<b>E17</b>	BT00.00-X-1000Z	<b>Technical modifications</b>	<b>21.6.99</b>
------------	-----------------	--------------------------------	----------------

BT03.20-P-0001-01A	Modified parallel key (metal version) for hub at crankshaft	ENGINE 602, 604, 605, 606	<b>F17</b>
BT03.20-P-0002-01A	Front crankshaft radial seal with reduced radial pressure stress	ENGINE 602, 604, 605, 606	<b>H17</b>
BT01.40-P-0001-01A	End cover with vulcanized radial seal		<b>M17</b>
BT03.30-P-0004-01A	Vibration damper vulcanized to belt pulley and brazed hub		<b>O17</b>
BT03.30-P-0003-01A	Vibration damper with unhardened contact surface for radial seal	ENGINE 602, 605, 606	<b>P17</b>
BT03.30-P-0001-01A	Bolt for two-mass flywheel modified		<b>C18</b>
BT03.30-P-0002-01A	Bolt for driven plate, flywheel, sheet metal two-mass flywheel standardized	ENGINE 111, 604, 605, 606	<b>D18</b>

<b>F17</b>	BT03.20-P-0001-01A	Modified parallel key (metal version) for hub at crankshaft	ENGINE 602, 604, 605, 606	 <b>BT</b>
------------	--------------------	---	---------------------------	---

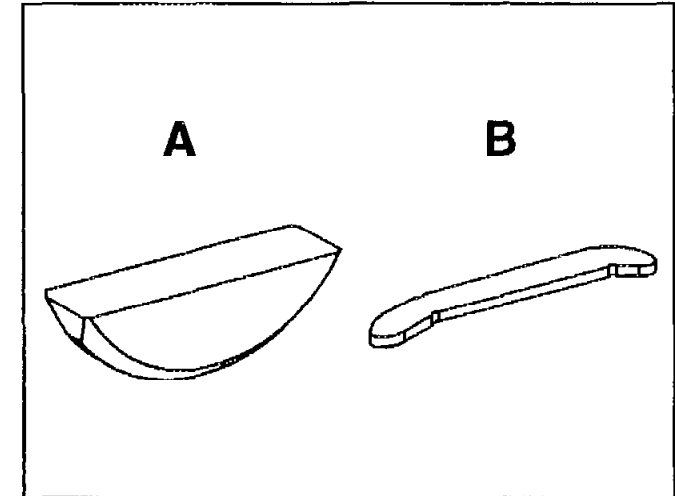
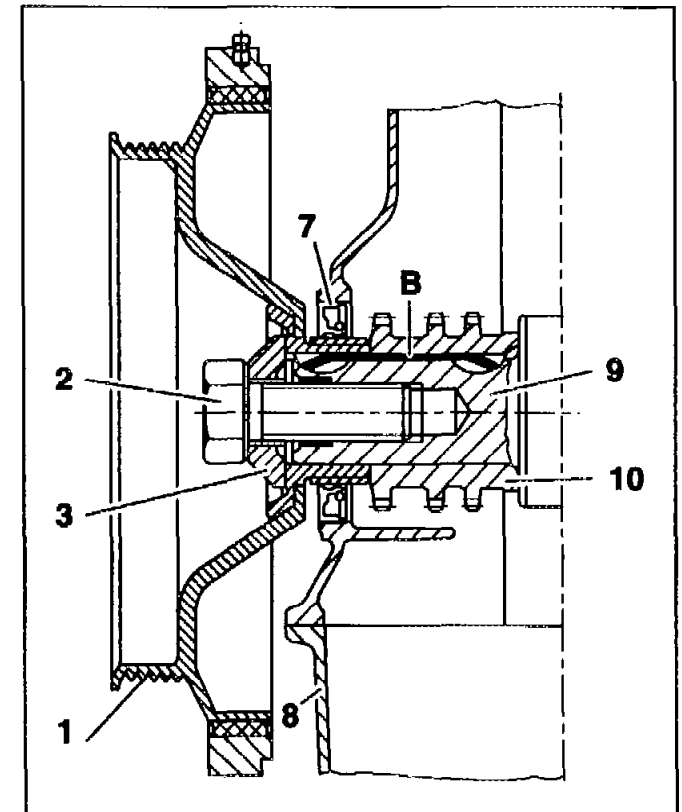
As a result of ongoing technical development, the ground woodruff key is replaced by a metal parallel key on the engines of the model designations listed.

- A *Woodruff key (previous)*
- B *Parallel key*

The parallel key version B no longer has to be aligned when installing the vibration damper (slip-proof, captive).

<b>H17</b>	BT03.20-P-0002-01A	Front crankshaft radial seal with reduced radial pressure stress	ENGINE 602, 604, 605, 606	 <b>BT</b>
------------	--------------------	--	---------------------------	---

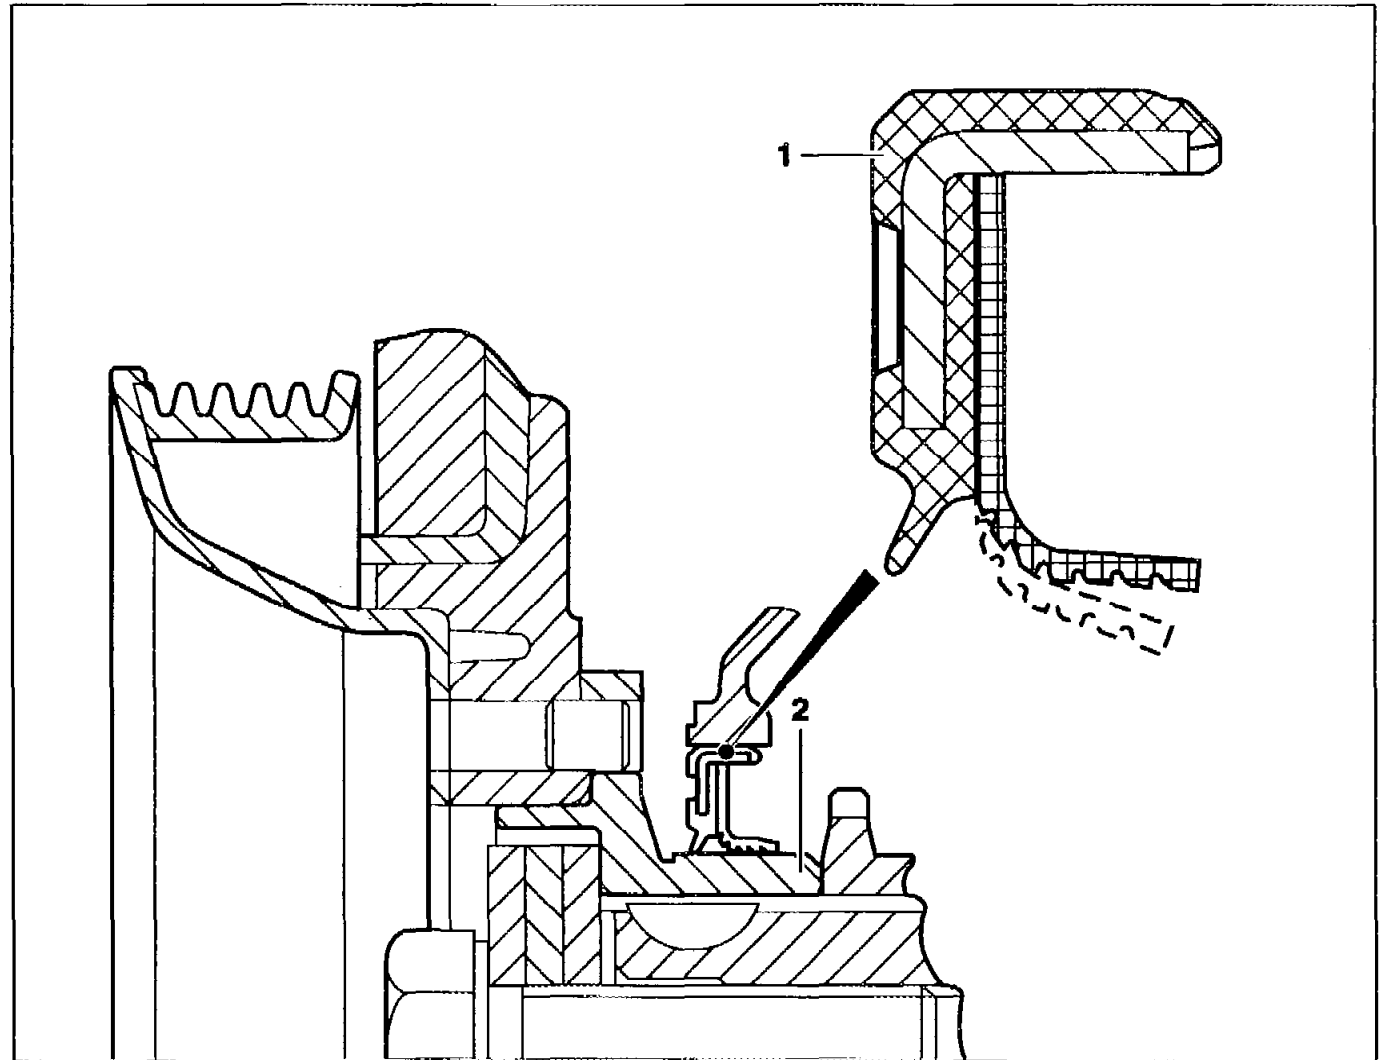
Since 07/97 crankshaft radial seals (1) with PTFE sealing lips (teflon coating) are installed at the front of the crankshaft on these engines. The vibration dampers will have a unhardened contact surface (2) in the future for the radial seal. Implementation of this modification at a later date. The crankshaft radial seals have a reduced radial pressure stress compared to the previous design.

The modified crankshaft radial seals can also be fitted to the engines listed below with hardened hub contact surfaces.

The previous crankshaft radial seals with conventional sealing edge must on no account be fitted to engines with unhardened hub contact surfaces as this combination would immediately result in leakages at the engine.

Because of the reduced wear of the contact surfaces, it is no longer necessary to install the crankshaft radial seal offset to the rear.

A new insertion tool is required to ensure that the sealing lip is not damaged when installing. This tool replaces the previous one. Do not apply pressure to the sealing lip of the radial seal.

<b>M17</b> BT01.40-P-0001-01A	End cover with vulcanized radial seal	 <b>BT</b>
-------------------------------	---------------------------------------	---

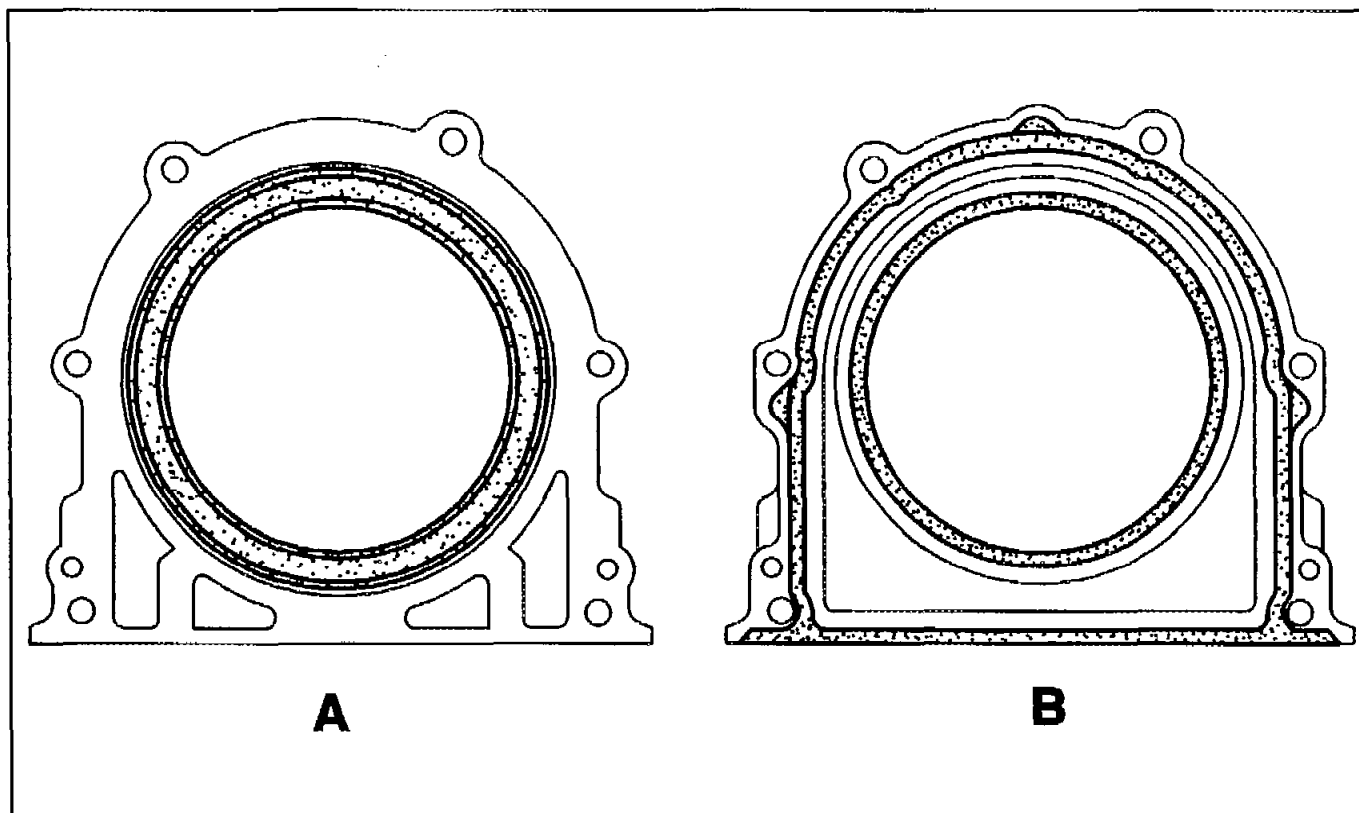
- A** *End cover with interference-fit radial seal*
- B** *End cover with vulcanized radial seal and vulcanized sealing lip (seal to crankcase)*

Vibration damper vulcanized to belt pulley  
and brazed hub

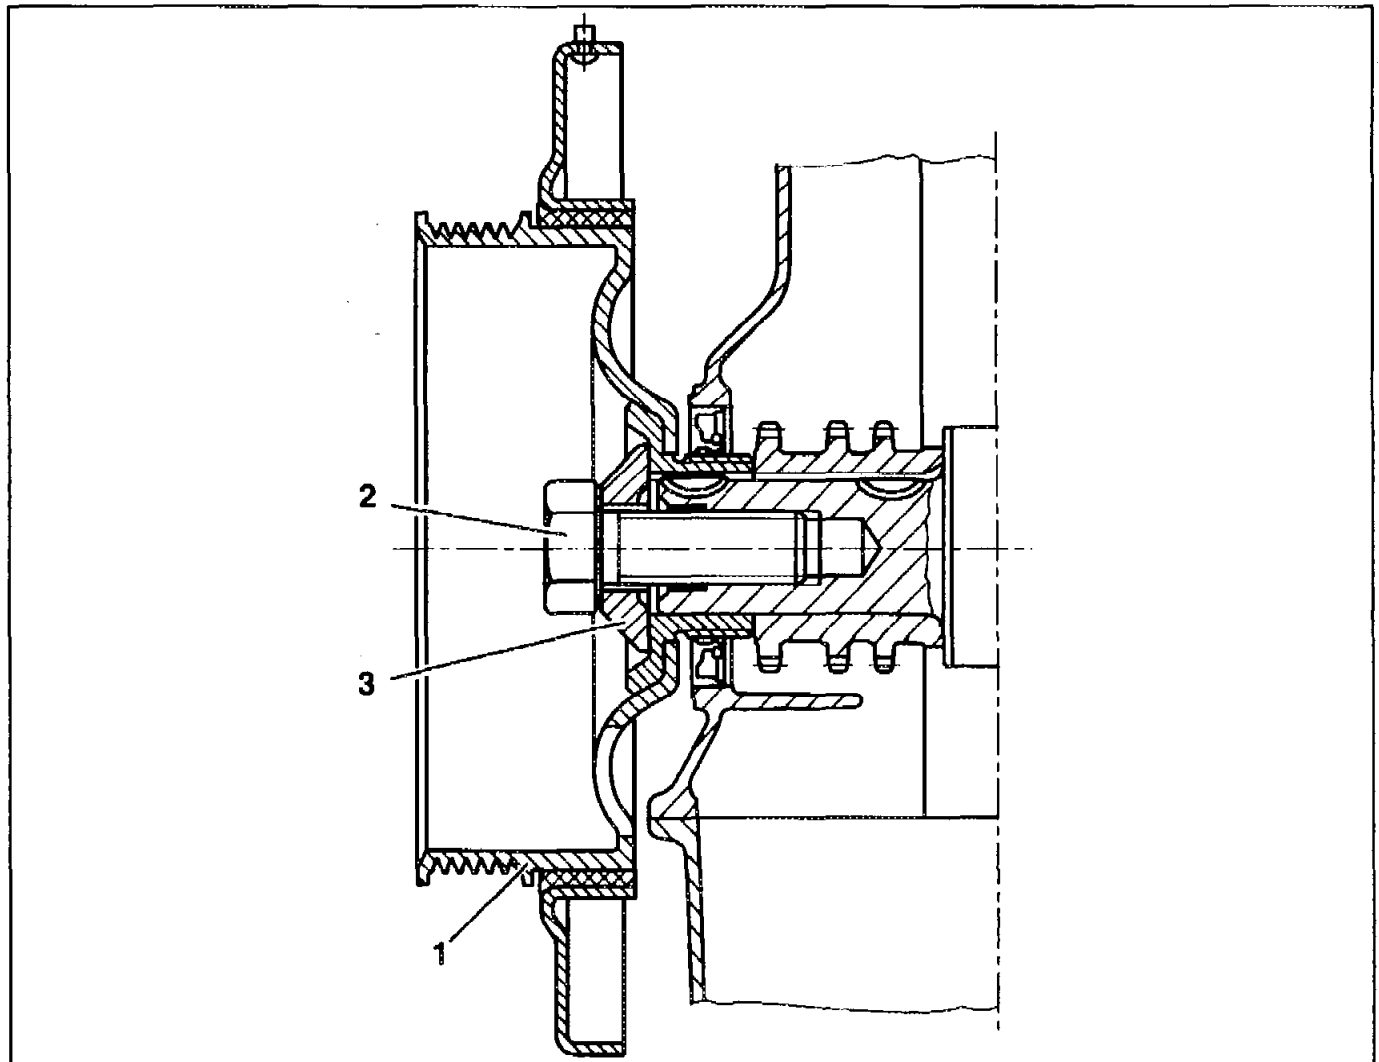
**i** With effect from the period stated  
above the hub is brazed to the vibration  
damper (1); was bolted.

<b>P17</b> BT03.30-P-0003-01A	Vibration damper with unhardened contact surface for radial seal	ENGINE 602, 605, 606	 <b>BT</b>
----------------------------------	---	----------------------	---

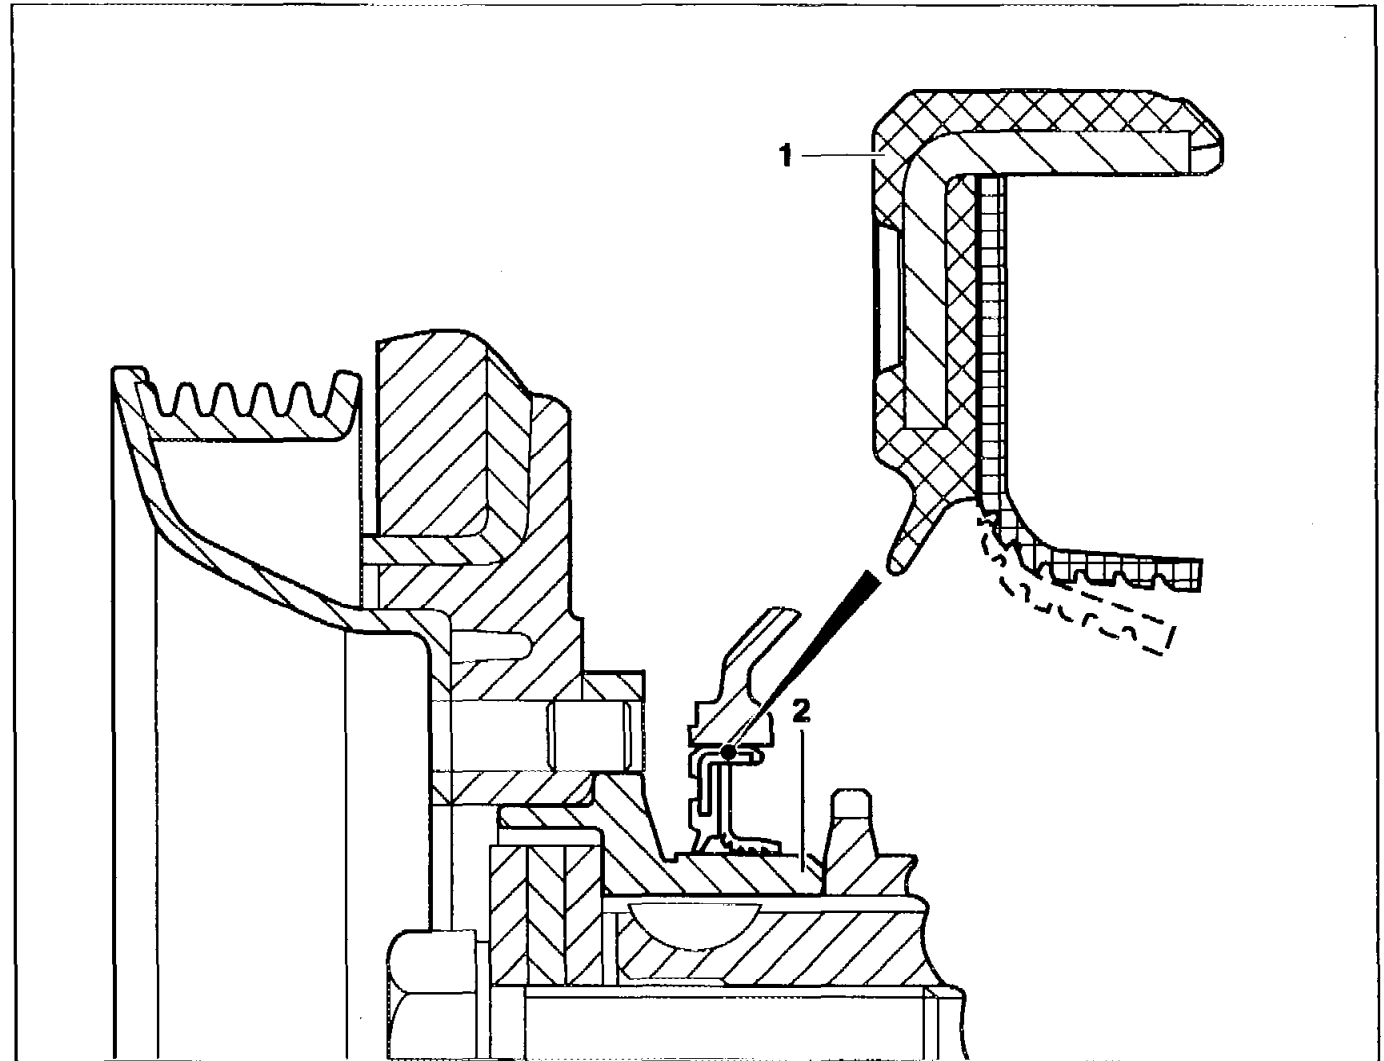
Vibration dampers with unhardened contact surface (2) are fitted to the engine stated above.

These vibration dampers must be fitted only in combination with the crankshaft radial seals (1) with PTFE sealing lips (teflon coating).

The raised part no. is indicated on the rear of the vibration damper, see table.

<b>C18</b>	BT03.30-P-0001-01A	Bolt for two-mass flywheel modified	BT
------------	--------------------	-------------------------------------	----

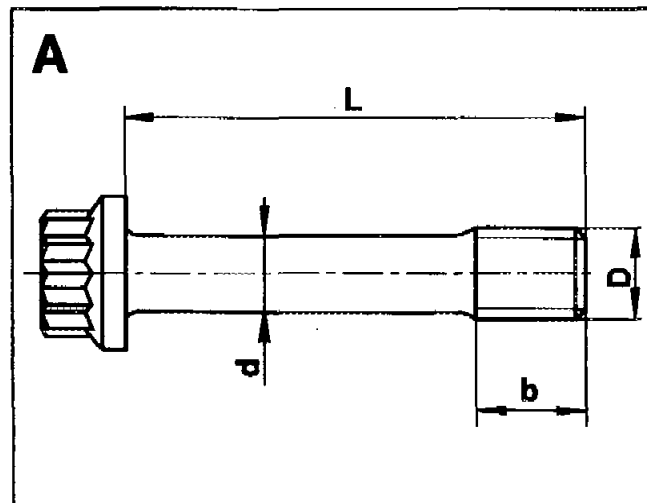
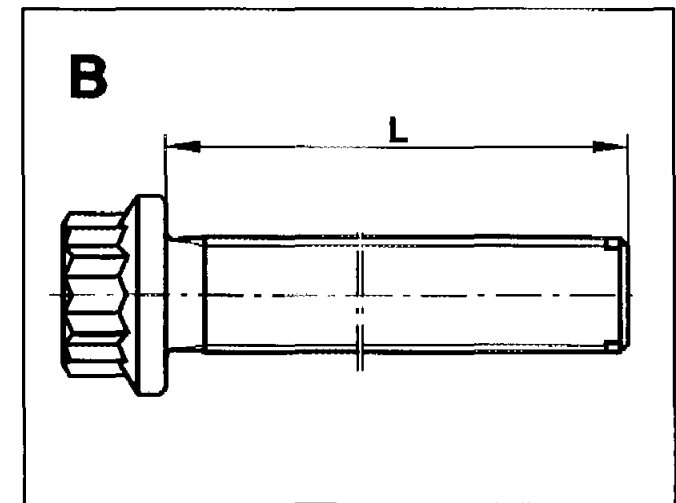
Stretch shank bolt (A)  
part no. 103 032 00 71 is replaced by a  
straight stretch shank bolt (B)  
part no. 111 032 00 71.

The straight stretch shank bolt (B) should be  
replaced when performing repairs.

Length (L)  $57 \pm 0.2$  mm

<b>D18</b> BT03.30-P-0002-01A	Bolt for driven plate, flywheel, sheet metal two-mass flywheel standardized	ENGINE 111, 604, 605, 606	 <b>BT</b>
-------------------------------	---	---------------------------	---

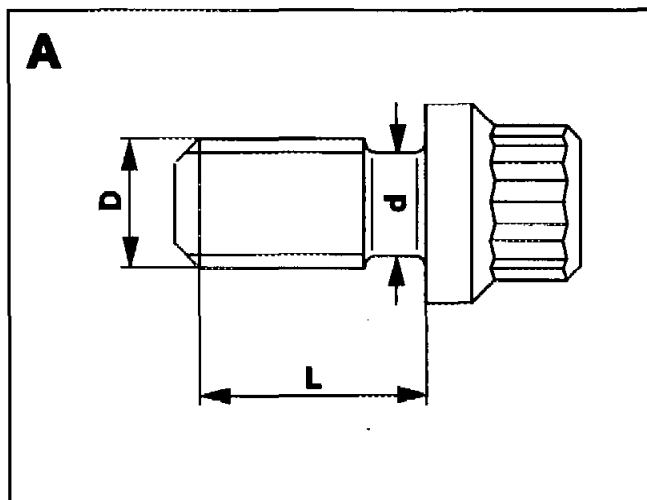
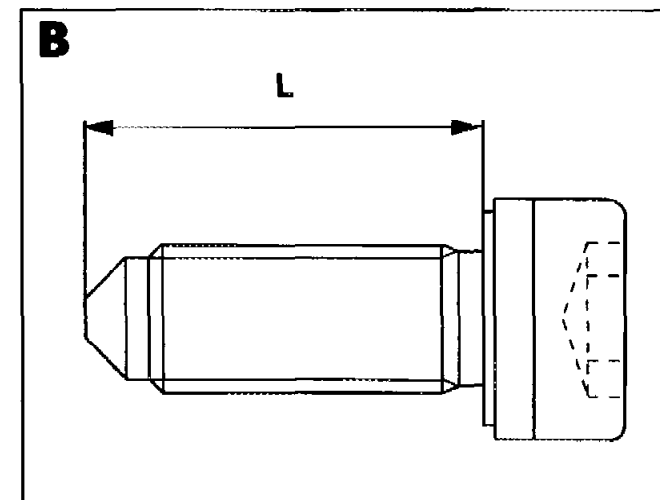
Stretch shank bolt (A) part no.  
102 032 00 71 is replaced by an internal torx  
bolt (B) T55 part no. 111 990 03 12.

The internal torx bolt (B) T55 should be  
replaced when performing repairs.

Length (L) bolt (A) = 22 mm

Length (L) bolt (B) = 28.5mm
